CONTRACT / ORDER

DATE OF CONTRACT / ORDER: 12 April 1967

ITEM NO.	SUPPLIES OR SERVICES	UNIT	QUANTITY (NO. OF UNITS)	UNIT PRICE	AMOUNT
	SCOPE OF WORK:				
25X1	The Contractor will modify a [redacted]				
25X1	[redacted] light table into a split format light table in accordance with the Contractor's proposal dated 21 February 1967 which is incorporated herein by reference and made a part of this contract. The table shall also be modified to provide a Versatile Stereoscope Carriage adapted for a fine focus mount and with motorized film transports.				
	SECURITY:				
	The equipment to be delivered hereunder is UNCLASSIFIED.				
	The association of the sponsor with the equipment being procured hereunder is

Dual Viewing Light Table Requirements (Mechanical only)

A. Lighted Surfaces

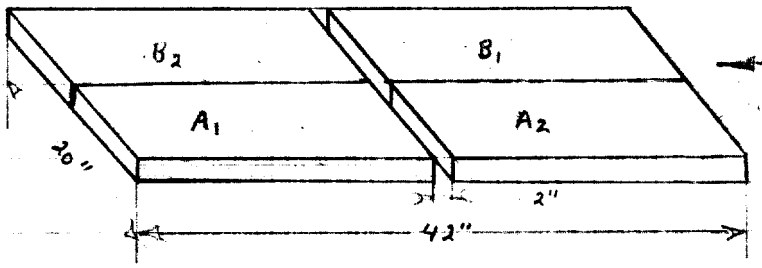
← two tables placed together

Possibility of sliding one light surface in X direction to facilitate film looping. [redacted] has a prototype which does this. Acceptable.
